Beaver Creek Coal Company
P. O. Box AU
Price, Utah 84501
Telephone 801 637-5050

Re: Thickener Overflow Pond
C.V. Spur
ACT/007/022
Carbon County, Utah

Please find enclosed three (3) copies of a proposed modification for the C.V. Spur drainage control system. This modification is submitted in response to your letter of November 22, 1982, concerning the thickener overflow pond and sediment pond capacities.

PLANT OVERFLOW POND

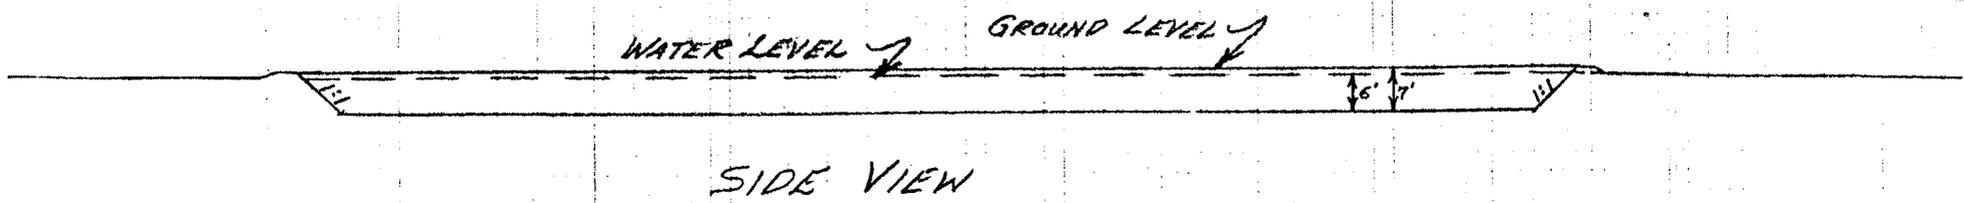
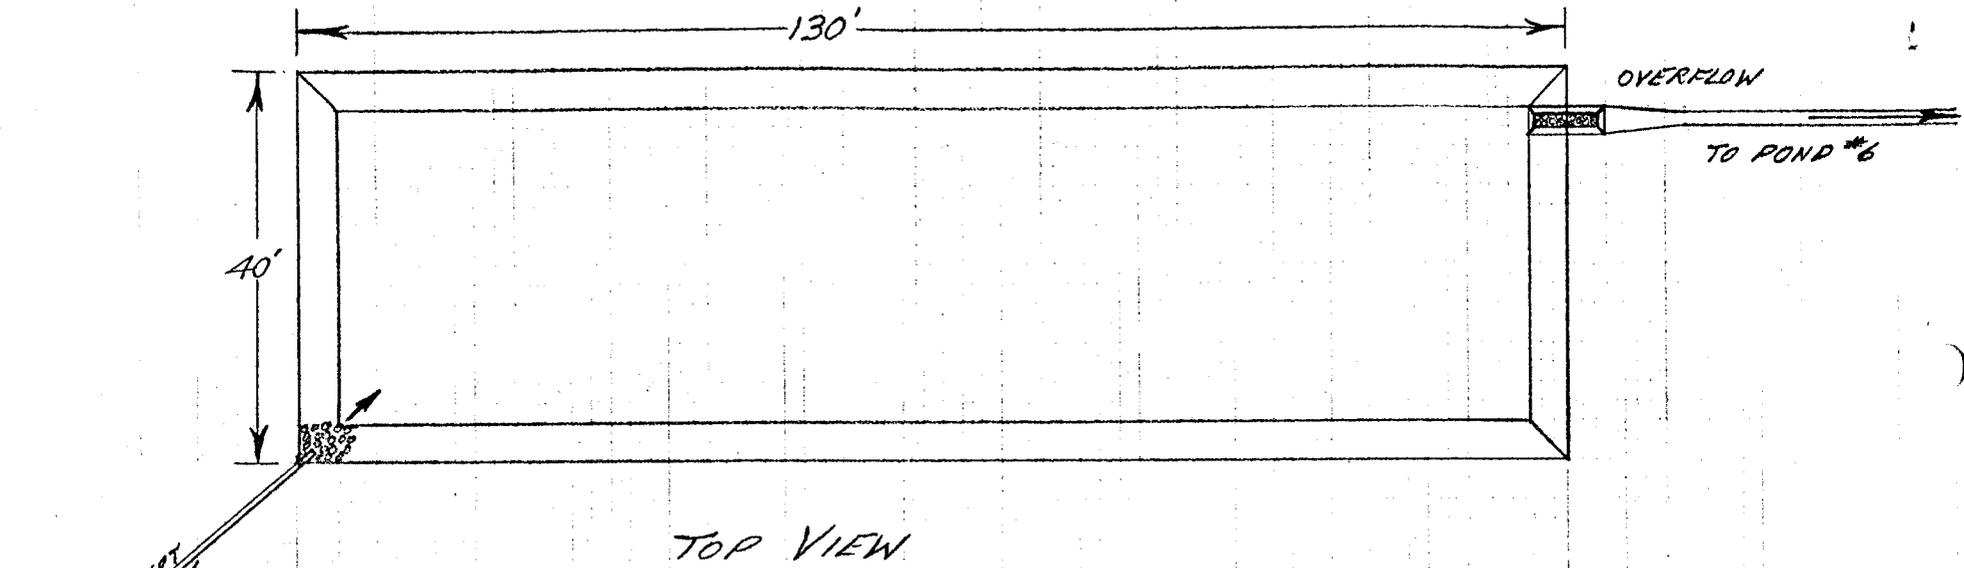
The proposal is to add a pond south of the existing Sediment Ponds 1, 2 & 3 to be used solely to contain plant discharge water in the event of recirculation problems. An occasional pump failure or plugging of the plant sump may lead to a discharge from the plant. This discharge will run between 0 and 40 gpm and will only occur until the system can be repaired. To eliminate the concern over using the existing sediment ponds to store this occasional overflow water, it is proposed to pipe any plant overflow water directly to the new pond. From this point, the water will be pumped as required into Pond #6 where it will be filtered and recirculated into the plant washing system. Since the outflow from the plant (and the pond dewatering) will be less than the filtering rate of Pond #6 (approximately 40 gpm), no capacity should be lost in Pond #6 during the dewatering.

The proposed pond will be 40 feet wide by 130 feet long and will be 7 feet deep. An emergency rip-rapped overflow will be placed 1 foot from the top and will flow into Pond #6. The proposed pond will have a capacity of 0.625 acre-feet and will be cleaned when the capacity is reduced by one-half.
